UNITED STATES PATENT AND TRADEMARK OFFICE

10/551,763

Office Action Summary	Application No. 10/551,763	Applicant(s) HAMIDI ET AL.	
	Examiner KHIEM D. NGUYEN	Art Unit 2823

DETAILED ACTION

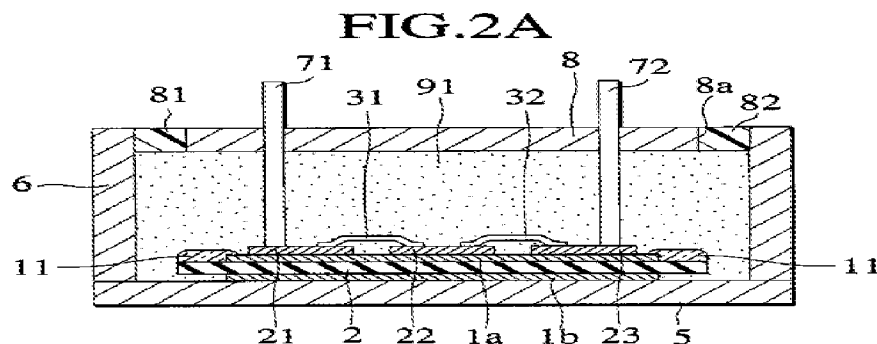
In re claim 7, **Shimizu et al.** disclose a power semiconductor module, comprising:
an electrically insulating substrate **2**; a first electrically conductive layer **1a** disposed on
at least one portion of a top surface of said electrically insulating substrate **2**, so as to
selectively expose at least one peripheral top region of said electrically insulating
substrate **2** (see col. 11, line 56 to col. 12, line 8 and FIG. 2A, for example);

at least one semiconductor power chip **21/23** mounted on said first electrically
conductive layer **1a** (see col. 12, lines 6-8);

a first electrically insulating material **11** disposed in a corner region formed by
said first electrically conductive layer **1a** and said peripheral region of said electrically

insulating substrate **2** ((see col. 12, lines 49-58 and FIG. 2A) and (col. 12, line 63 to col. 13, line 12 and FIG. 2B));

a second insulating material **91** at least partially embedding said semiconductor power chip **21/23**, said electrically insulating substrate **2**, said first electrically conductive layer **1a**, and said first electrically insulating material **11** (col. 11, lines 58-62 and FIG. 2A, for example);

wherein the first electrically insulating material **11** is a polyimide (col. 12, lines 49-58), and

In re claim 8, as applied to claim 7 above, **Shimizu et al.** discloses all claimed limitations including the limitation wherein the electrically insulating substrate **2** is mounted on a bottom plate **5** (see col. 12, lines 9-13 and FIG. 2A, for example).

In re claim 13, as applied to claim 7 above, **Shimizu et al.** discloses all claimed limitations including the limitation wherein the first electrically insulating material **11** fills gaps in a junction between the first electrically conductive layer 1a and the electrically insulating substrate **2** (see col. 12, lines 49-63 and FIG. 2A).

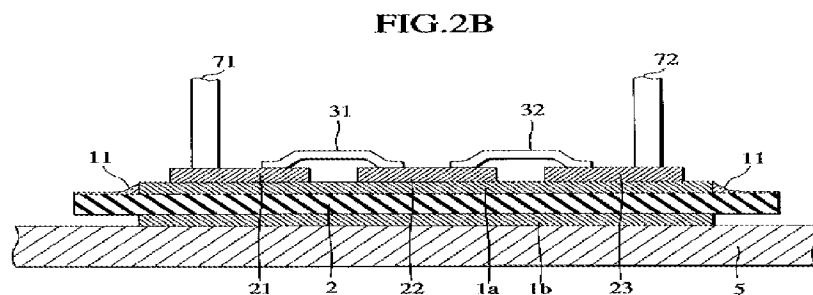
the surface of the first electrically insulating material **11** disposed in the corner region formed by said first electrically conductive layer **1a** and said peripheral region of said electrically insulating substrate **2** is concave-shaped (see col. 12, line 63 to col. 13, line 12 and FIG. 2B, for example).
